Attachment J4

Submissions

Figure 13: View impact assessment of existing views provided to Unit 12, 12 Onslow Avenue and future views as a result of the proposed development.

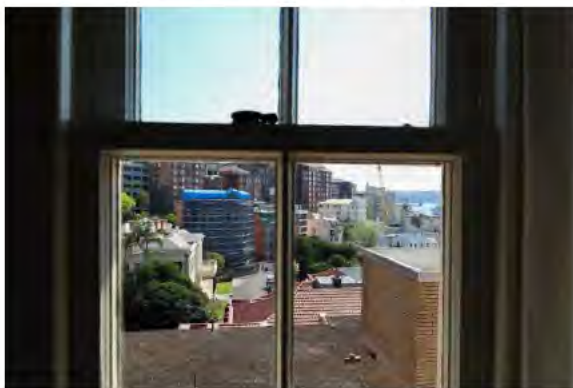
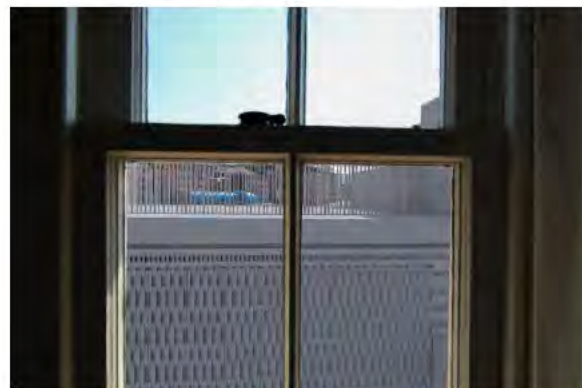
A view loss assessment has been carried out by Urbaine which discredits the comments provided above. The assessment has found that the proposal will result in severe to devastating impacts as significant views from parts of Port Jackson, Elizabeth Bay, Garden Island, Fort Denison and the foreshore of the

suburbs around Kurraba Point will be impacted upon as viewed from the balcony of unit 12 (refer to Figure 13).

The view loss from the office of unit 12 has been assessed as being of severe impact, as the development will obscure views of the heritage-listed Elizabeth Bay House, Onslow Avenue and its street landscape and the Harbour water view, Fort Denison, Kurraba Point and the distant ridgeline, together with sky views.

Figure 14: Excerpt of overshadowing diagram utilised by applicant to show overshadowing as a result of a non-complaint building height.

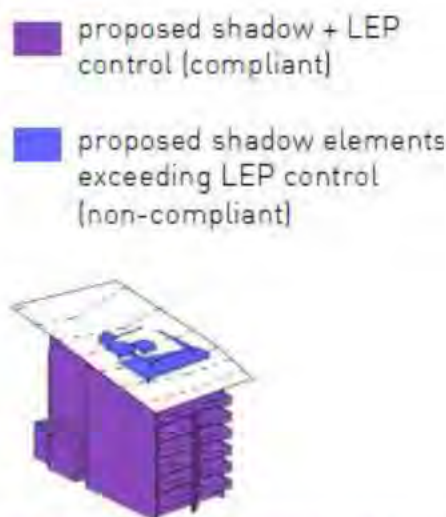
In addition to the above, the shadow diagrams prepared to accompany the DA cannot be relied upon for the purpose of shadow elements that have occurred due to 'non-complaint' aspects of the development (refer to Figure 14) because the building height calculated for the development is incorrect as established within point one of this submission.

Figure 15: Attachment 2 of Flood Impact and Risk Management Report.

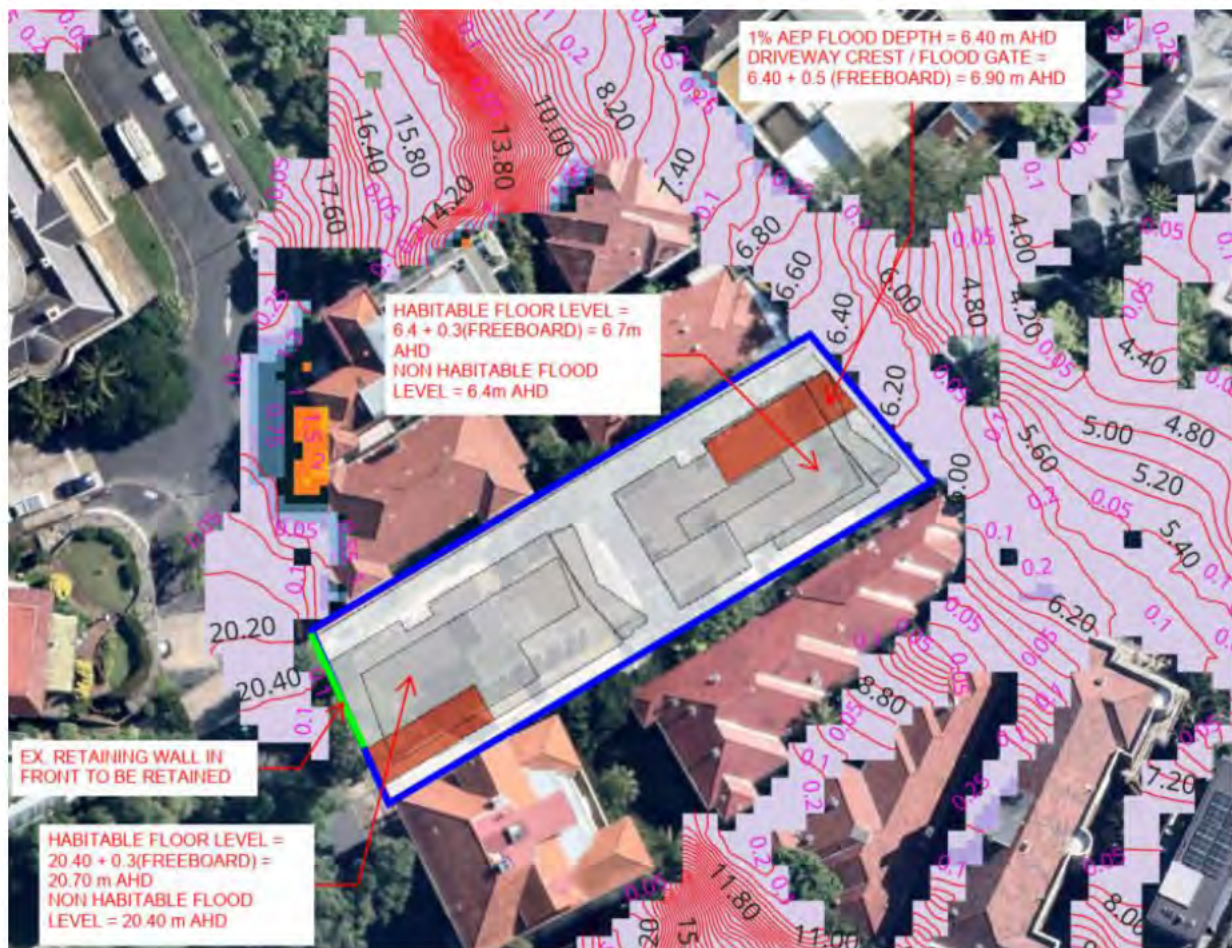
The site is affected by overland flows and a Flood Impact Report has been prepared for the DA. The assessment has outlined that the habitable floor levels for the development must be provided in accordance with Figure 15. The development, however, has habitable floor levels for the building fronting Onslow Avenue starting at RL14.5, which lies below the required habitable floor level of RL20.70.

The development does not satisfy clause 5.20 of SLEP and is a reason for refusal.

View from Onslow Avenue looking south

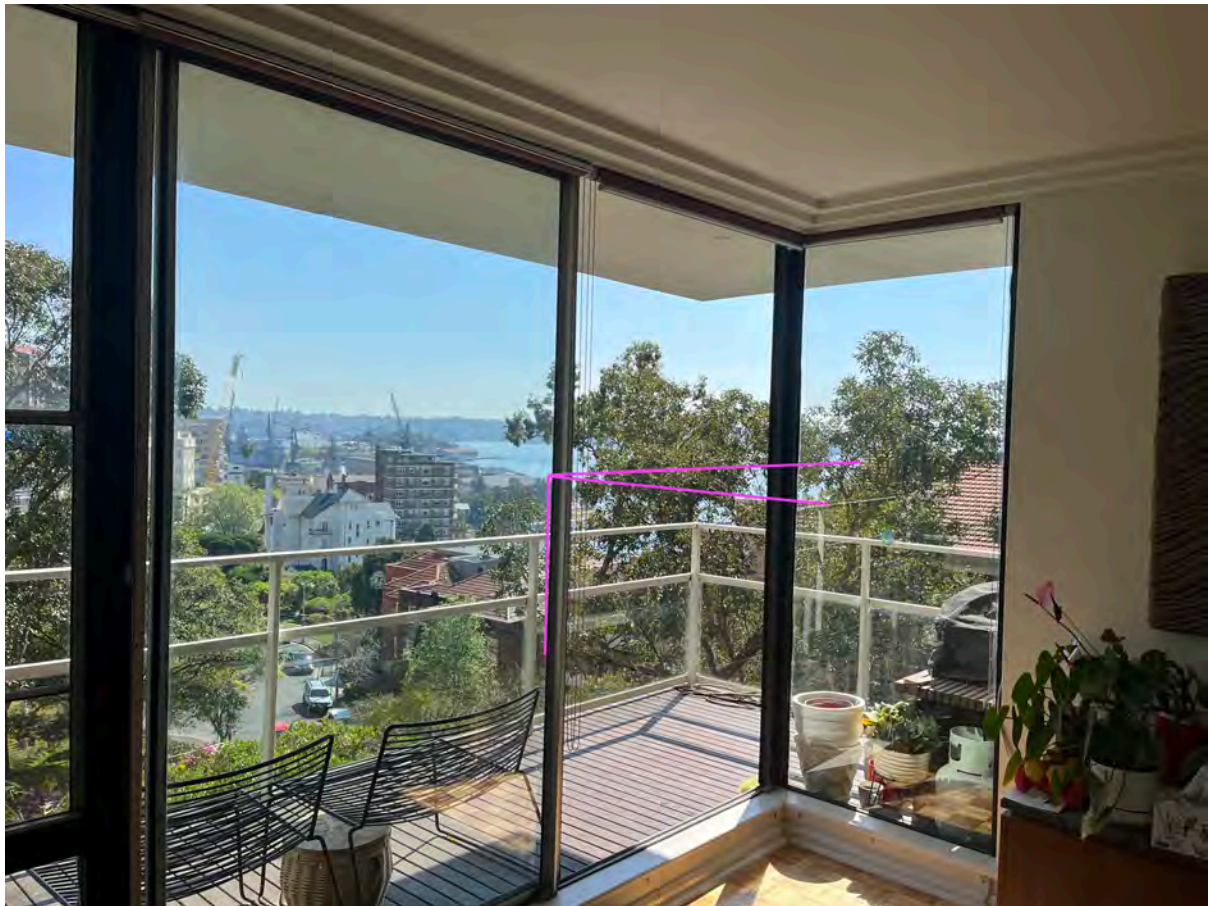
The upper level setback of approximately 2m will also create a much more dominate built form within the streetscape. Clause 2.4.6 (b) states development is to respond to and complement heritage items and contributory buildings within heritage conservation areas, including streetscapes and lanes. The transition in height appears to be out of scale and character to the adjacent context. Based on the above the proposal should increase the upper level setback to the street and reduce the height of the building to be complementary to the streetscape in the heritage conservation area.

Further no streetscape photomontages have been included in the documents. Can the architect please provide existing and proposed photomontages looking north and south along Onslow Avenue.

Figure 2. Projected devastating loss of views of Elizabeth Bay House from the kitchen/dining room of apartment 6 in Darnley Hall, 12 Onslow Avenue, if the current proposal goes ahead.

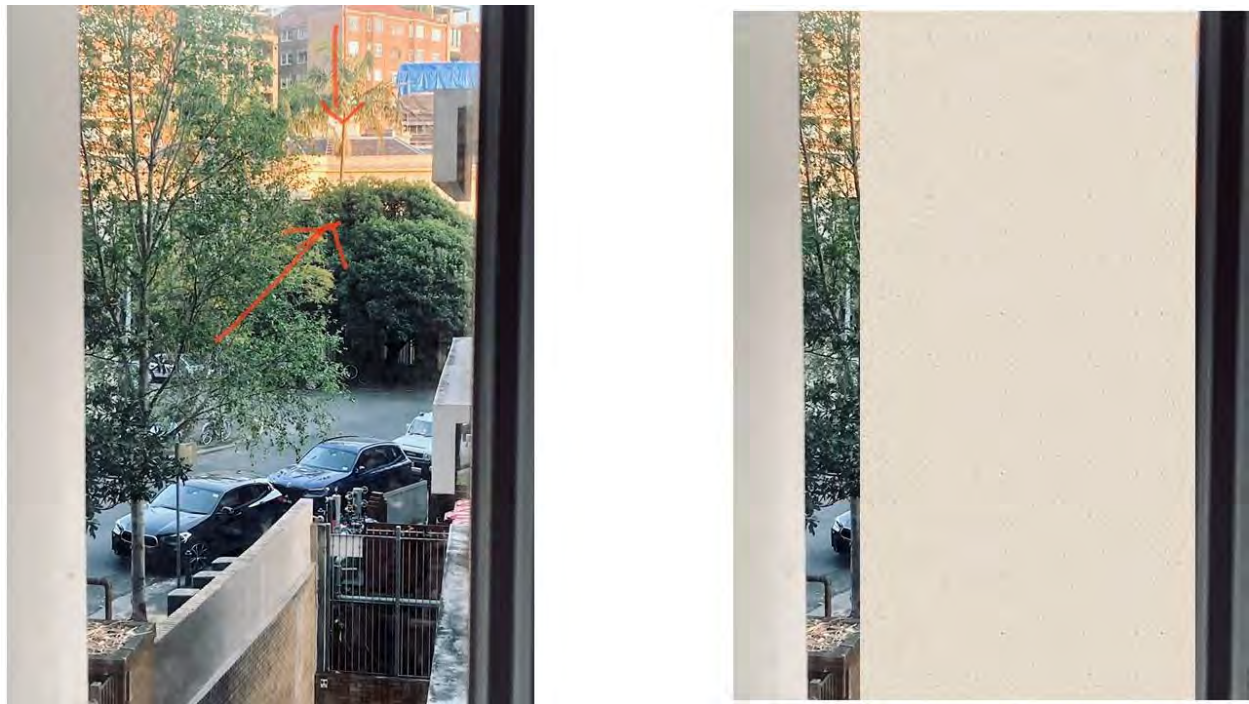
Similarly, the proposed development with its reduced setbacks and increased height (significantly exceeding height regulations) will dramatically alter the solar access. In particular, our apartment will lose significant direct sunlight and experience increased overshadowing and reduced overall natural light. This will entirely alter the ways in which we experience key living areas in our apartment. As the available light and views in these rooms were integral to our decision to buy and renovate this apartment, I believe we will have no choice other than to sell if the proposed development goes ahead. Further, in light of the above impacts there is no doubt that the market value of this apartment will be badly affected. Residents should not be driven out of their homes by incompatible development.

Figure 4. Characteristic wide setbacks between buildings along Onslow Avenue, Elizabeth Bay.

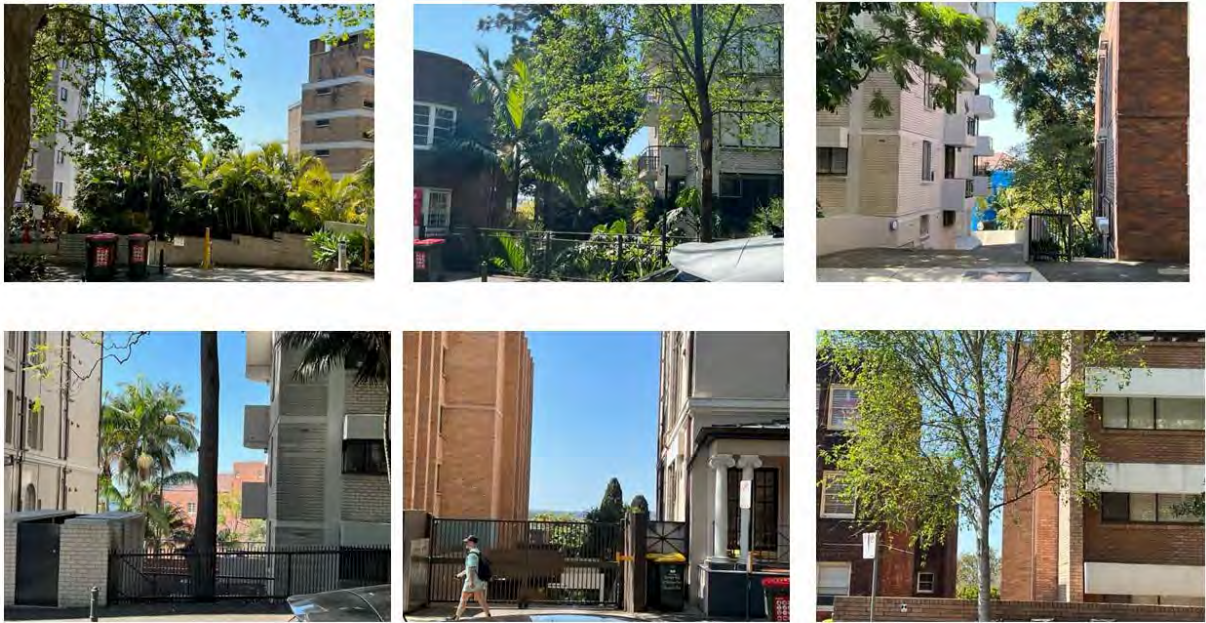
The proposed development involves a radical reduction in the space between Darnley Hall and the structure at 10 Onslow/21C Billyard Avenue. This will result in a range of negative impacts for our apartment, including reduced light, loss of privacy, increased noise etc. [*Design in Context: Guidelines for Infill Development in the Heritage Environment*](#) (2005) is clear that “where there is an established pattern of side setbacks that contribute to the character of the streetscape this should also be reinforced by new buildings” (p.10). It also specifically notes that “building with minimum setbacks on both sides where this is not the pattern, can increase the bulk of the building and have an obtrusive and unacceptable impact” (p. 11). Documentation for the proposed development offers images of narrow setbacks in the local area but specifically avoids images of the current more generous setbacks in Onslow Avenue and at either side of Darnley Hall. The latter are key to our building’s historical setting and to the ability of passersby to appreciate the full architectural impact of Darnley Hall.

Figure 5. Basement car park proximity to 23 Billyard Avenue, drawing DA103 Rev.A. (Smart Design Studio) Annotation added

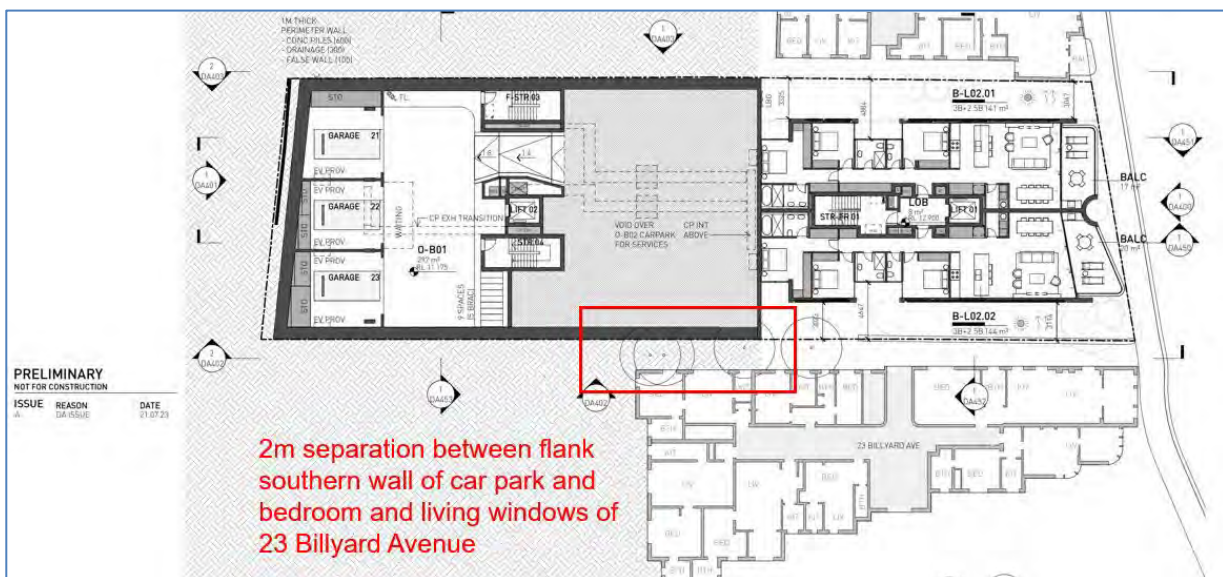
Of further note is the interface between the flank southern wall of the proposed basement car park (where this rises above ground level) and a number of the bedroom and living windows of 23 Billyard Avenue. The car park basement wall offers a **0m setback** to the site boundary. In total there would be only an approximate 2m separation to these 23 Billyard Avenue windows. The separation from this proposed wall to the neighbouring building is a significant reduction from the existing building which ranges from 5.9m – 6.7m.

The 0m setback and proximity to the existing windows is illustrated by the mark-up of DA drawings DA103 Rev.A and DA401 Rev.A, (**Figures 5 and 6**) below. The car park external wall is the same height as the top of the **2nd floor** level of 23 Billyard Avenue.

Figure 8. Impact on direct sunlight received by north-facing apartments, 23 Billyard Avenue (Source: Architectural Plans, Smart Design Studio)

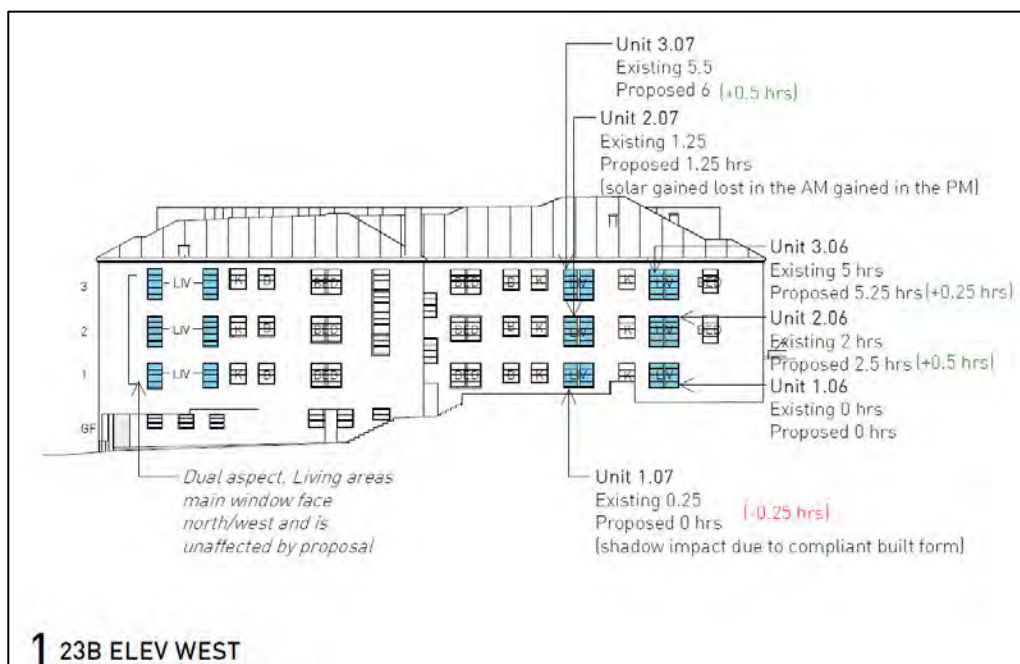
Cumulatively, the proposal also reduces the direct sunlight received by units 2.02, 1.02, GF.02, and LG1.02 at 12 Onslow Avenue at mid-winter. This exceeds other minor increases, as shown in **Figure 8** and **Figure 9** below, extracted from pages 53 and 54 of the Smart Design Studio architectural plans.

In this scenario, Design guidance under ADG Objective 3B-2 states that *“If the proposal will significantly reduce the solar access of neighbours, building separation should be increased beyond minimums contained in section 3F Visual privacy”*. Furthermore, *“Overshadowing should be minimised to the south or down hill by increased upper level setbacks”*. The same principle is reiterated in draft City of Sydney guidance ‘*Minimising overshadowing of neighbouring apartments*’.

Figure 9. Height Exceedance Diagrams (Source: applicant Clause 4.6 Variation Report, Urbis)

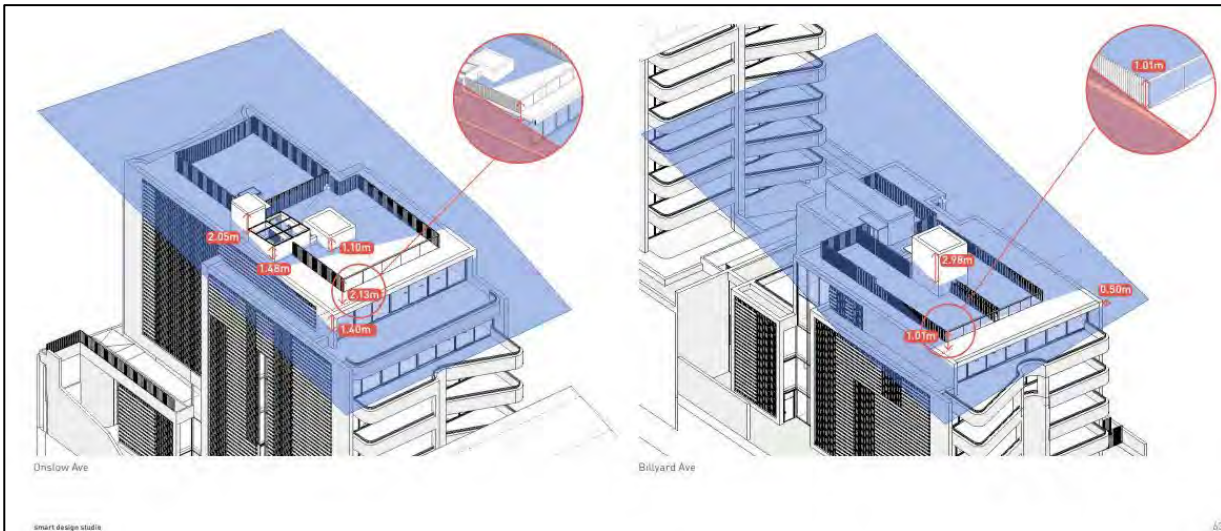
A Clause 4.6 Variation Request has been undertaken on behalf of the applicant, demonstrating a non-compliance with clause 4.3 of SLEP 2012. The proposed height exceedance (as shown in **Figure 9** below) includes not only the lift overrun, but also the roof terrace on the Onslow Avenue building and leading edge of the top floor of the Billyard Avenue building. This exceedance is unreasonable, impacting on the height transition between the adjoining properties and fostering detrimental amenity impacts.

The proposed exceedance in building height is not consistent with the objectives of clause 4.3 of SLEP 2012. Particularly regarding clause 4.3(1)(c) of SLEP 2012, which is *'To promote the sharing of views outside Central Sydney'*. The cumulative impact of the additional height and scale results in the proposal undermining objectives of clause 4.3(1)(c) of SLEP 2012, as the upper massing proposed does block views to the sky and imposes on the solar amenity of surrounding buildings.

Figure 11. North/south façade detail (Source: applicant Design Report, Smart Design Studio)

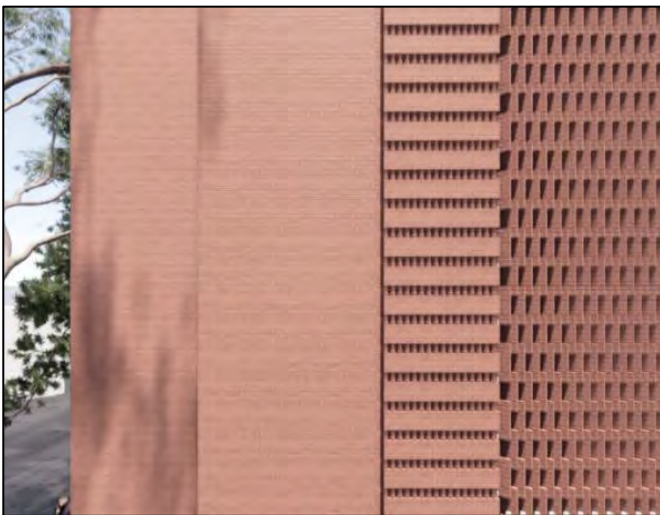
The 'experience' of pedestrians will only be for a few seconds. More important will be the experience of the existing residents of the neighbouring properties, particularly at 21B and 23 Billyard Avenue, who will only be able to see these blank brick elevations from their living rooms and other windows. Refer to **Figure 10** and **11** below. In this regard, the proposal does not demonstrate design excellence in accordance with clause 6.21 of the SLEP 2012. Refinement is needed to the design of the north and south elevations of the development, to create greater variety, visual interest, and responsiveness to the context of the proposed building.
